Protecting the Sovereignty of the Kalispel Tribe in the Pend Oreille River Temperature TMDL

Presentation to EPA Headquarters
July 24, 2012 • Washington D.C.

Comparison of temperatures under existing and natural conditions at the upstream end of the Kalispel Tribe's reservation (River Mile 72)

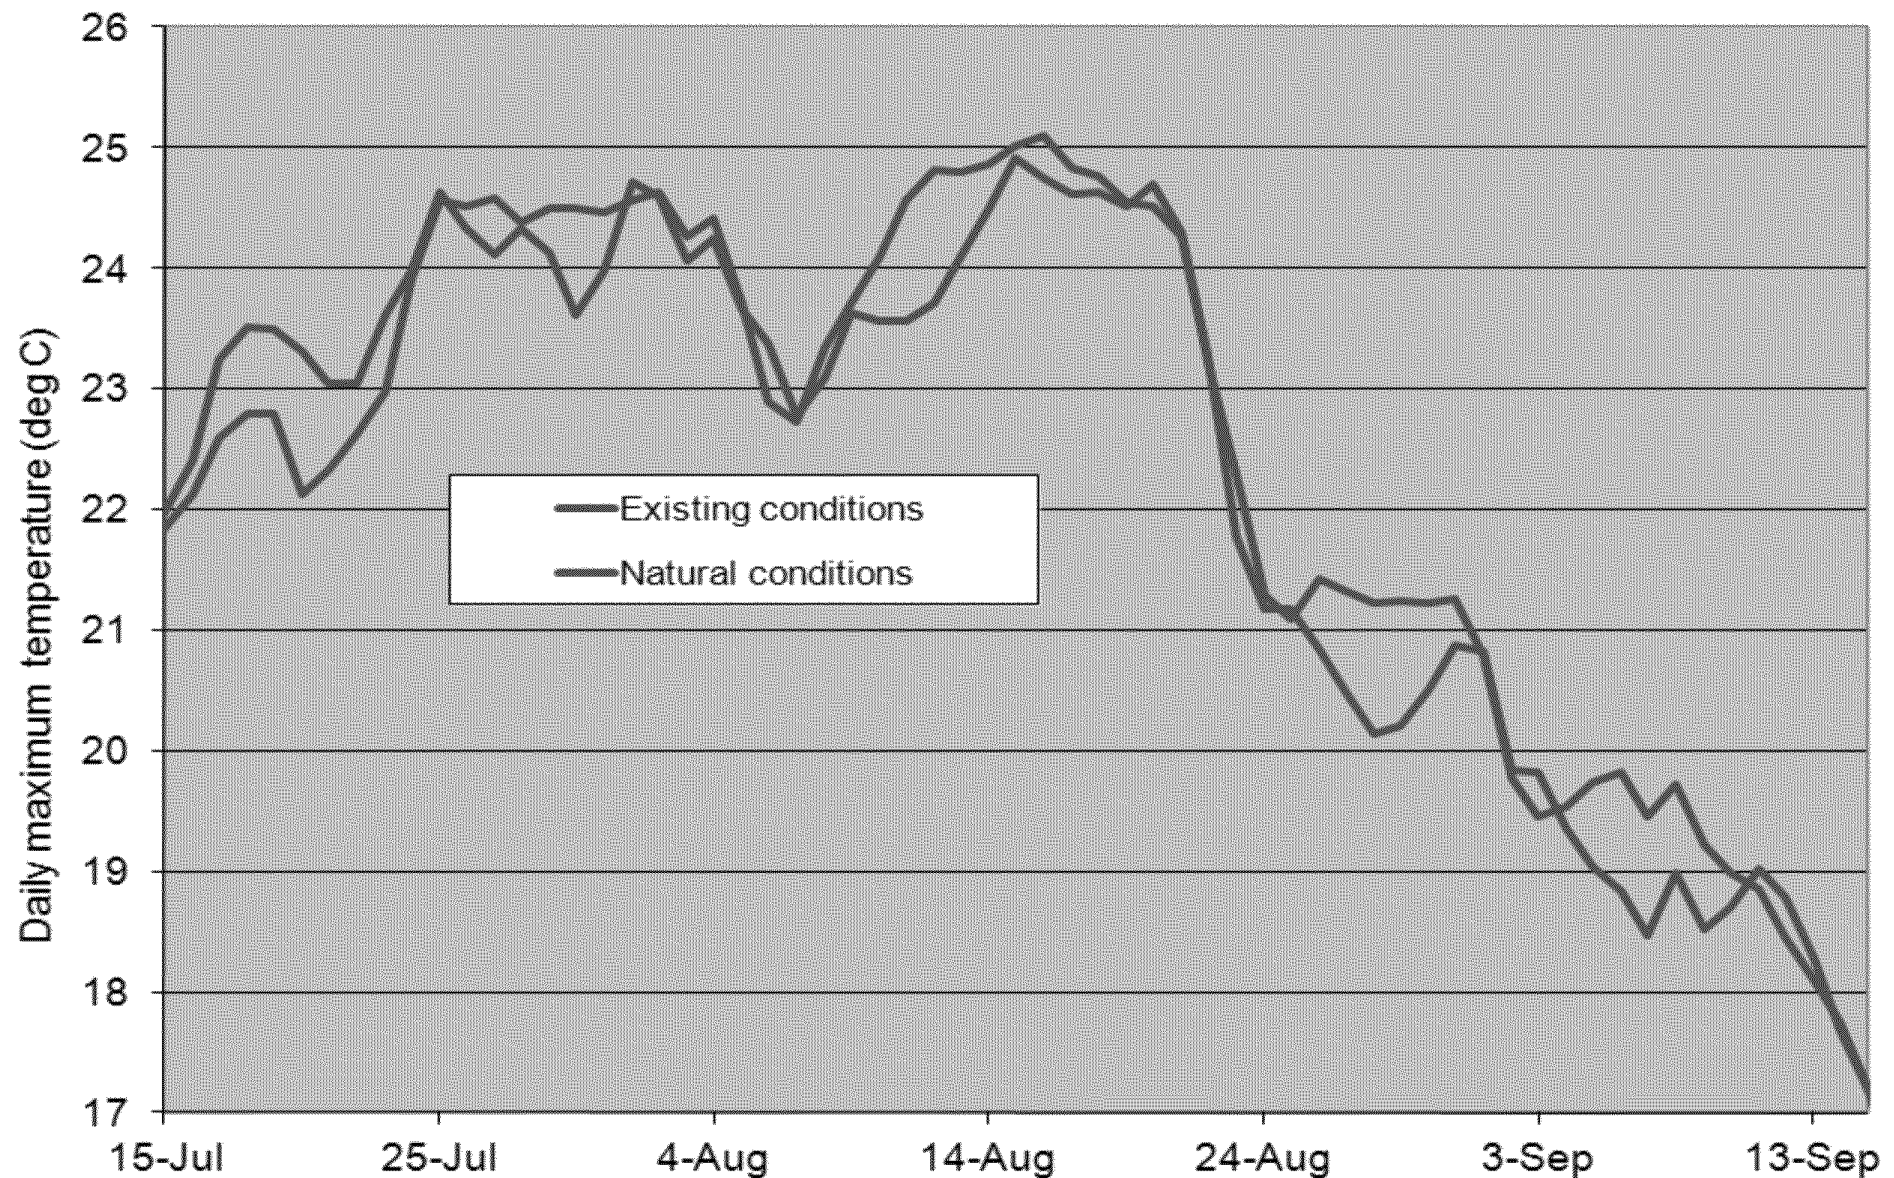
- * CFA is necessary to account for time lag
 - * Next slide shows that there is no significant time lag
 - * Even if time lag were an issue, the pooling period does not correspond to the lag
 - * The selected remedy for the lag (93-day CFA) is grossly disproportionate to a time lag that is on the order of days according to Ecology, and at most 1 day on tribal waters
